Navigability of the Santa Cruz River

T.A.J. Gookin P.E., R.L.S., P.H., S.W.R.S.

This report was prepared on behalf of the Gila River Indian Community (“Community”). The Gila River Indian Community is a federally recognized Indian tribe and occupies the Gila River Indian Reservation (“Reservation”). This report is being prepared at the Community’s request for presentation to the Arizona Navigable Stream Adjudication Commission (“ANSAC”) for its use in determining the navigability of the main stem of the Santa Cruz River. The purpose of this report is to review the report by Hjalmarson entitled "Navigability Along the Natural Channel of the Santa Cruz River" ("Report") and the "Declaration of Rich Burtell" ("Declaration").

Figure 5. Flow duration relations for middle Santa Cruz River.

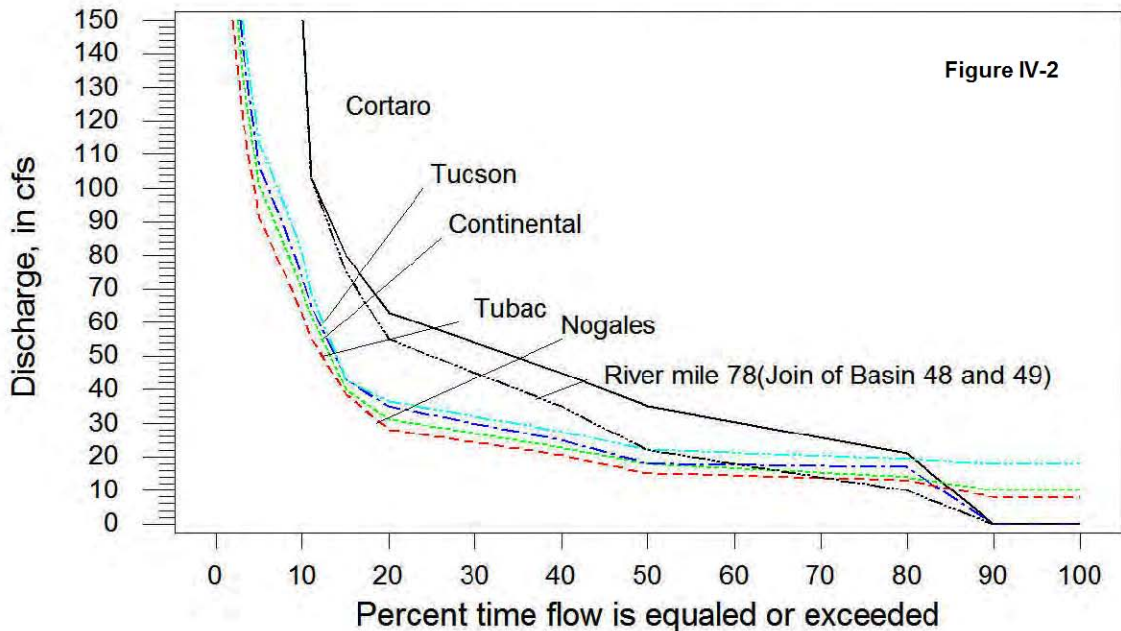
The Nogales Curve is plotted based on the data presented for Nogales by Hjalmarson¹¹ in his Santa Cruz report. It is obvious from Hjalmarson's figure 5 that the flow-duration curves are plotted by locating certain key values and drawing straight lines in between. The problem is the data¹² show values for 67%, 34%, 19%, 6% and 4% frequency. Ignoring the 6% and 4% points, which may be reflected in the curve (it is hard to tell), the points plotted are at 11%, 15%, 20%, 50%, 80%, and 90%. The 19% point from the data and the 20% point I measured from Hjalmarson's figure 5 are probably the same point (I am just scaling off an enlarged print of the figure 5 curves), but there is no indication as to where the data for the 11%, 15%, 50%, 80%, and 90% points on the graph come from or what happened to the 67% and 34% data

If, as Hjalmarson states,¹³ he uses the ratios of virgin flow to historic flow to multiply the historic curve, then you would expect the 34% data point, which had an historic value of 5 cfs, to have a virgin flow of 6.9 cfs.¹⁴ Instead it is plotted as being 26 cfs.

It is certainly possible that instead of using the procedure that he explained¹⁵, Hjalmarson just added the 8 cfs baseflow value that he calculated¹⁶ (the difference between the "White Book" average virgin flow and average historic flow converted to cfs)¹⁷ to all values, but then the 34% virgin flow values should be 13 cfs.¹⁸ I cannot approximate the 26 cfs.

The 67% value showed 1 cfs in the source data, but is plotted as being about 12.5 cfs. If the multiplication procedure is used, the resulting value would only be about 1.3 cfs. If the addition procedure is used the resulting value is 9 cfs.

The curves presented by Hjalmarson have been artificially adjusted. If the reader looks at Figure 5 of Hjalmarson's report (reproduced here as Figure IV-2) and examines the lines at 80%, there is an artificial break at that point in all but the Tucson line. The Continental, Tubac, and Cortaro (aka Rillito) lines are extremely obvious. All three of the lines then head directly to 0 cfs, all at exactly the 90% probability. This adjustment allows the curve shapes to account for the historic observations of the Santa Cruz being dry without forcing the curves above the 80% to dip down to their correct levels. The Nogales and Tubac curves are more subtle and dip down to Hjalmarson's assumed base flow numbers at 90%.

Figure V-2

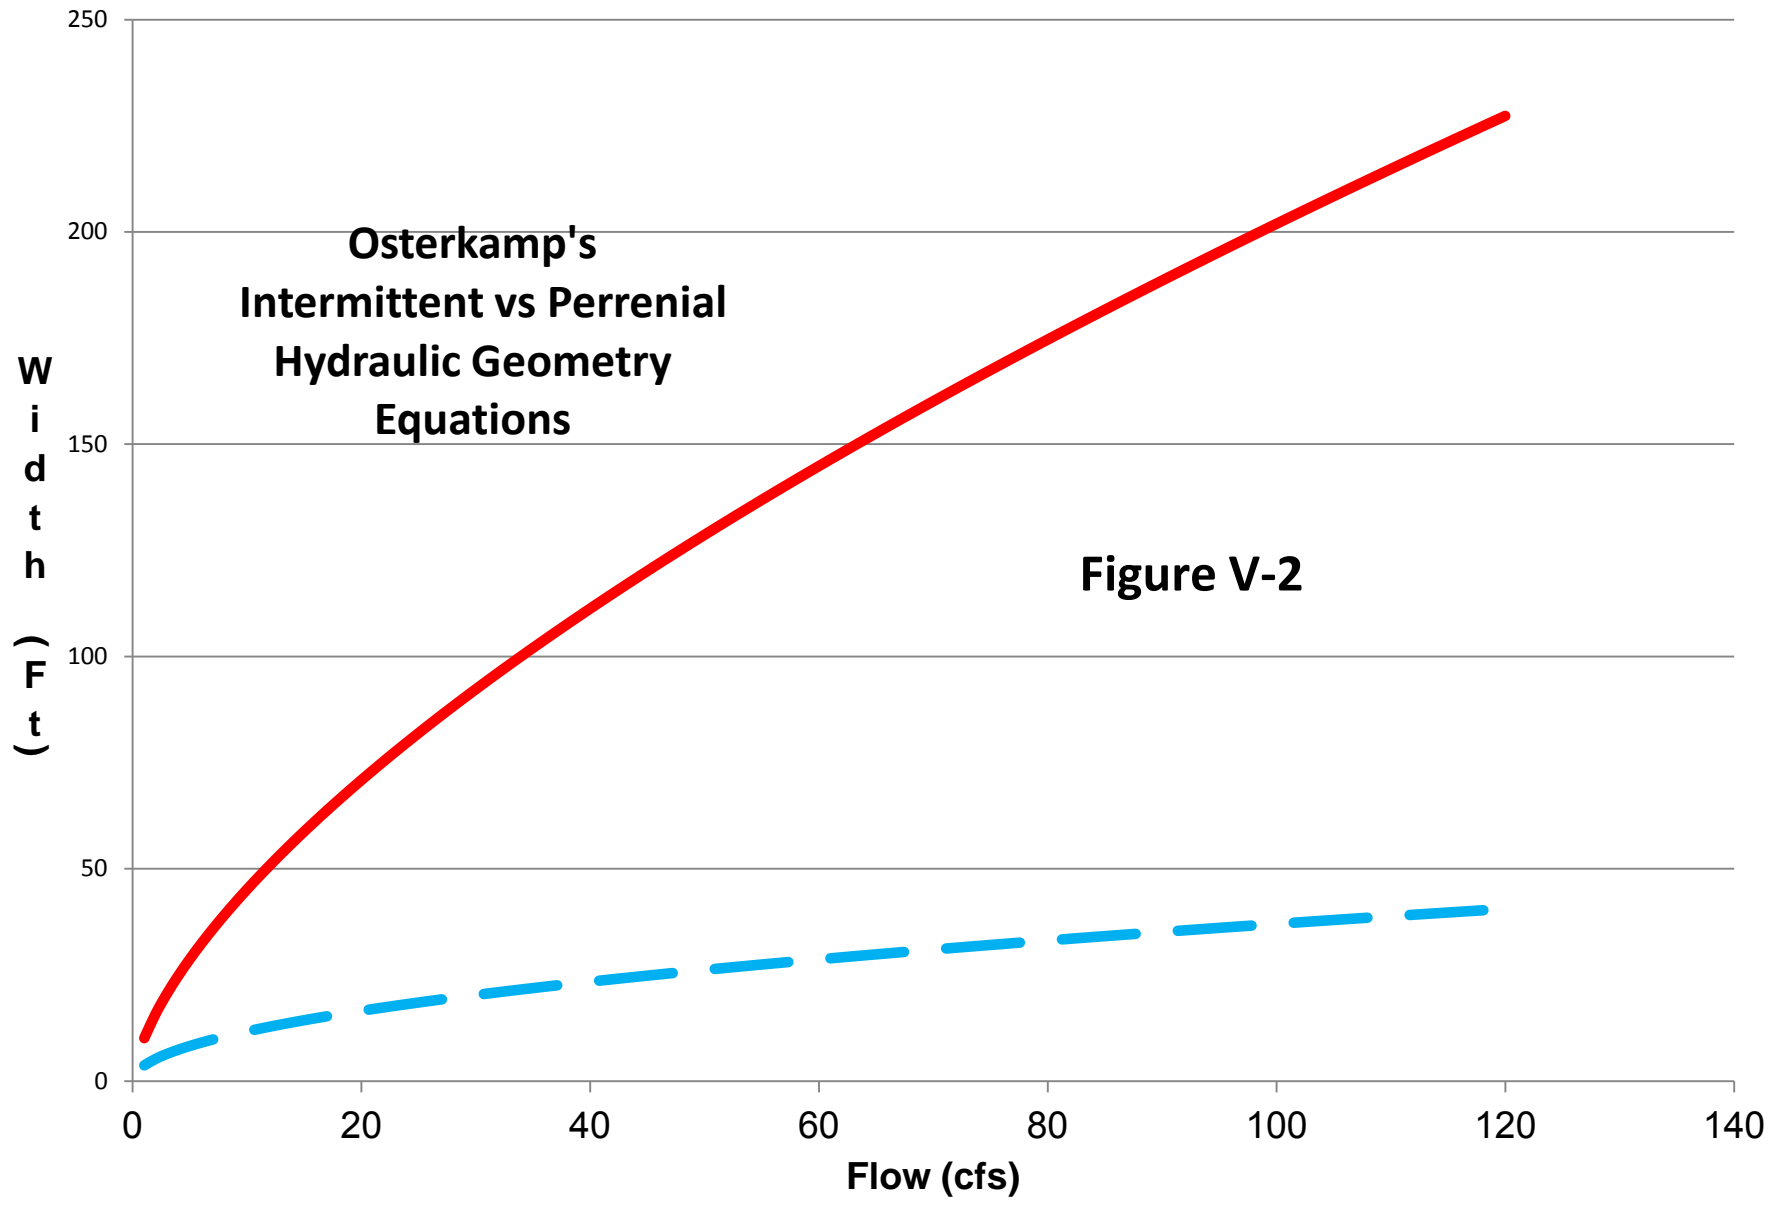
These two equations are dramatically different as shown on Figure V-2. The two formulae predict that an intermittent channel is dramatically wider than a perennial channel for a given flow. This is consistent with physical reality. Because the width is dramatically greater, it follows that the depth of the river would be significantly less.

Figure VI-1a

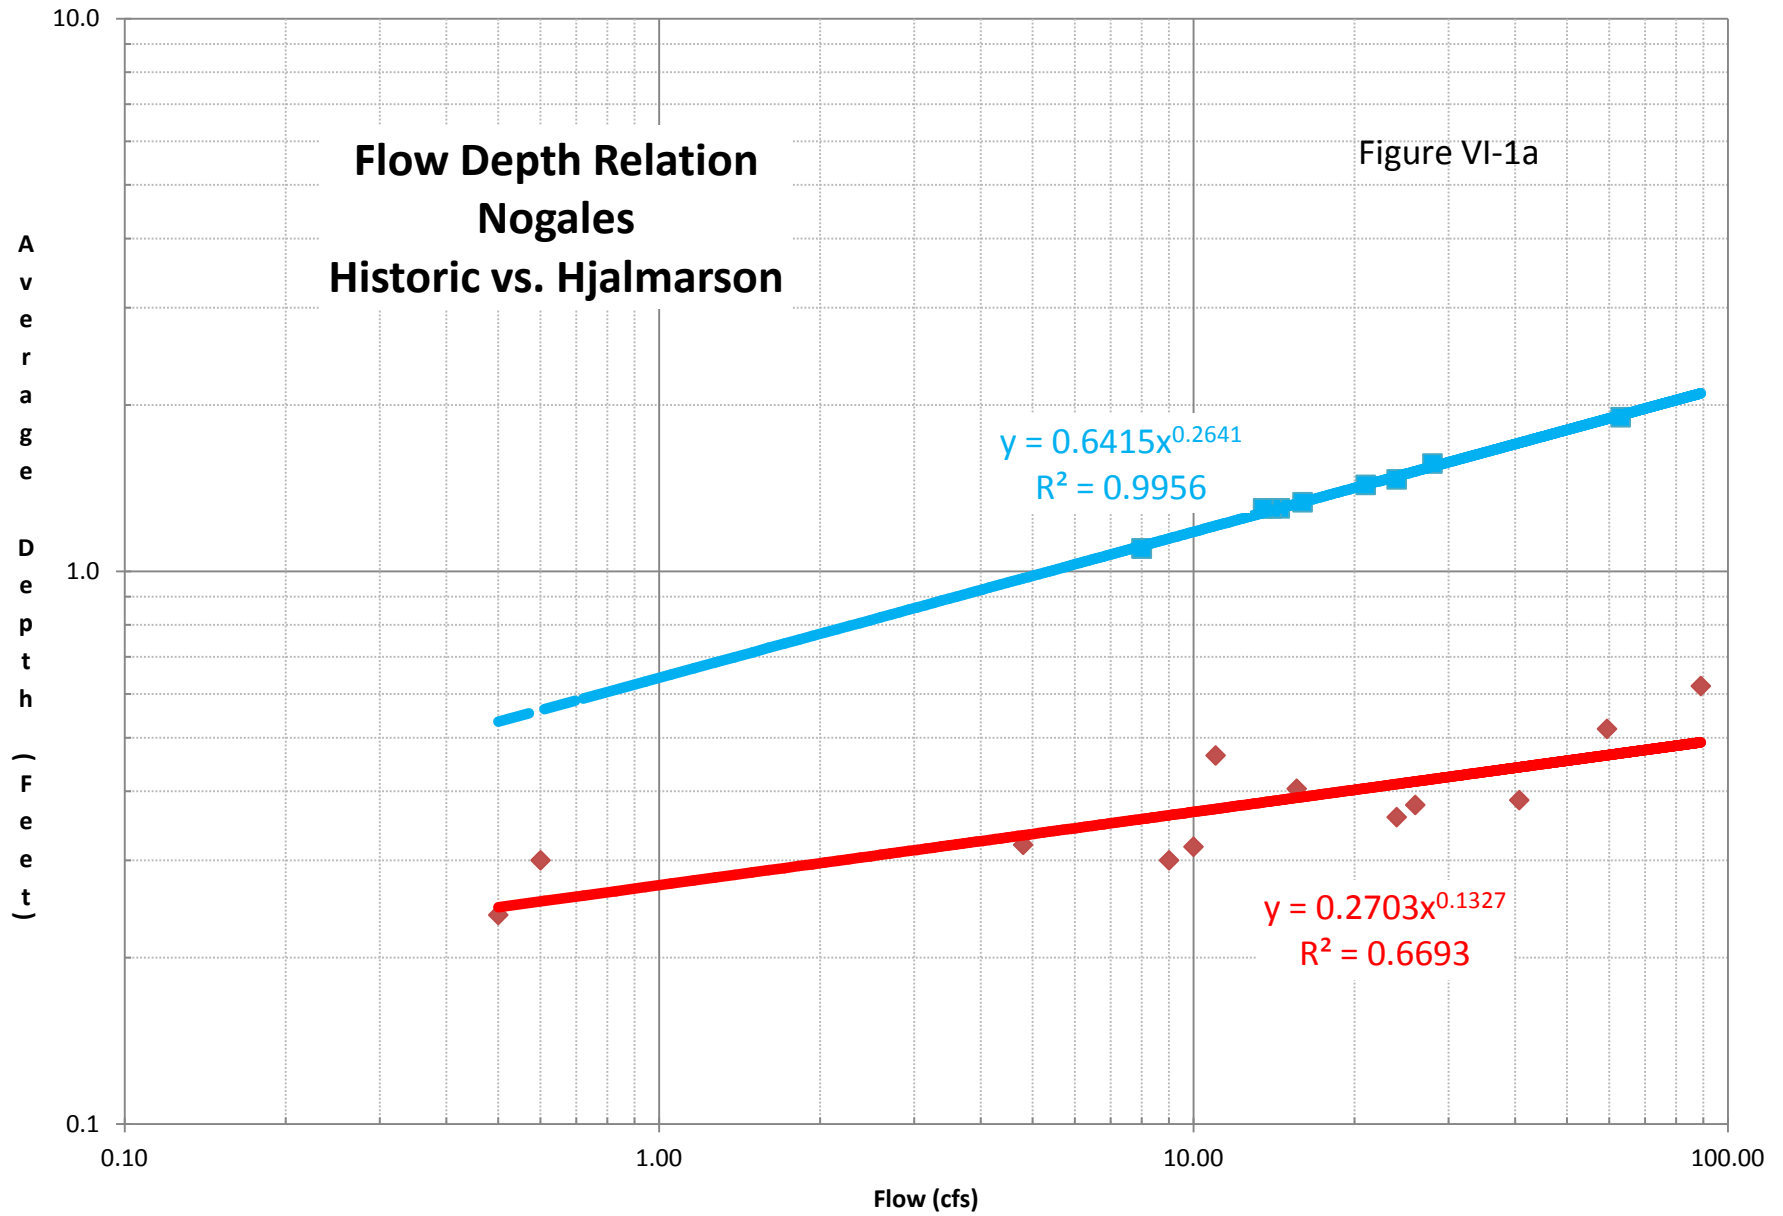
This analysis has been done for both the Nogales Gage and the Tucson Gage. As can be seen, the Hjalmarson reconstruction of the flow-depth relationships considerably overstates depths. In the following chapter, there is a considerable discussion about the depth of water required. The values that are cited are 1 foot, 2 feet, and 3 feet. Figure VI-2 contains the flow rates to depth values that are the statistical result of the data.

To reasonably guarantee the required flow depths, a safety margin should be added. I did not do so in this analysis. Also the two gage locations are in places where the Santa Cruz was perennial and the most favorable for navigation along the Santa Cruz. The dry reaches would be significantly less likely to be navigable. To eliminate argument about the probability of flow, I am using the flow and depth values from Hjalmarson's Report (his Figures 5 and 12). As indicated in Chapter IV, I believe the chart is not substantiated by his data.
